## Urgent Field Safety Notice

**Title / Subject:** Field Safety Notice: BWS-L Yoke 2019

**Document ID:** FSN-002

**Commercial name of the affected product:** Body-Weight Support Light (BWS-L)

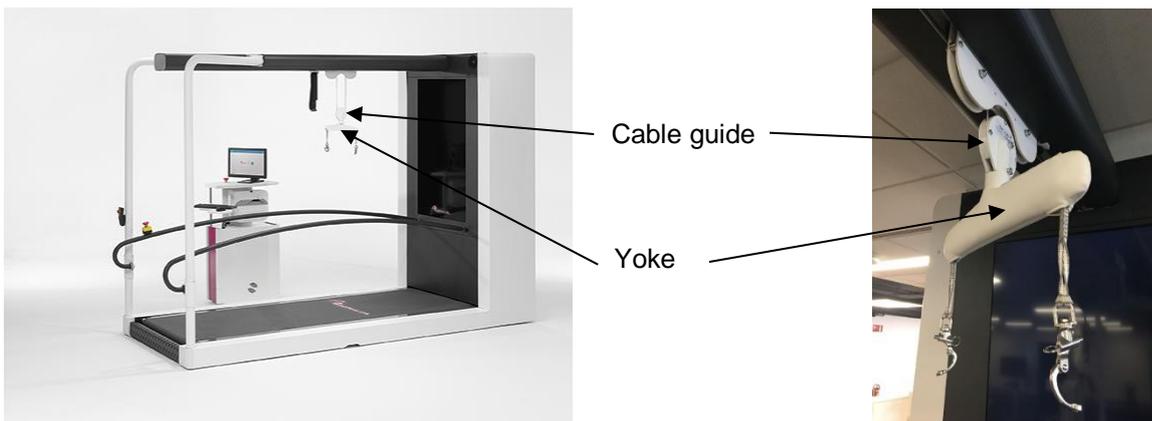
We have discovered a potential manufacturing deviation of the yoke of the BWS-L that in rare occasions may result in the yoke detaching from the cable guide.

In our risk-analysis, we have determined that if the padded yoke detaches during treatment, the patient will be caught in the safety harness that is connected to the system via a separate safety belt. In such a situation, the padded yoke may make contact with the head of patient and can potentially cause significant discomfort. However, please pay special attention if you use the BWS-L with patients with cranial deficiencies.

**If you are treating patients with cranial deficiencies, stop using the BWS-L for these patients immediately, as the hazardous situation of the detachment of the yoke might result in serious or even deadly harm.**

- A. You request a Yoke Replacement Kit to be send to you directly, such that a skilled person from your institute can do the replacement under our remote supervision. The replacement consists of removing two easily accessible bolts, replacing the affected components, and reinserting two new bolts. Verification will require you to take two pictures of the reinserted bolts, and confirmation by Motek Medical BV is needed before you can use the system again for patients with cranial deficiencies. Detailed instructions will be provided. The difficulty level of this replacement is low (similar to assembling IKEA furniture) and the entire procedure should only take 15 minutes using basic tools.
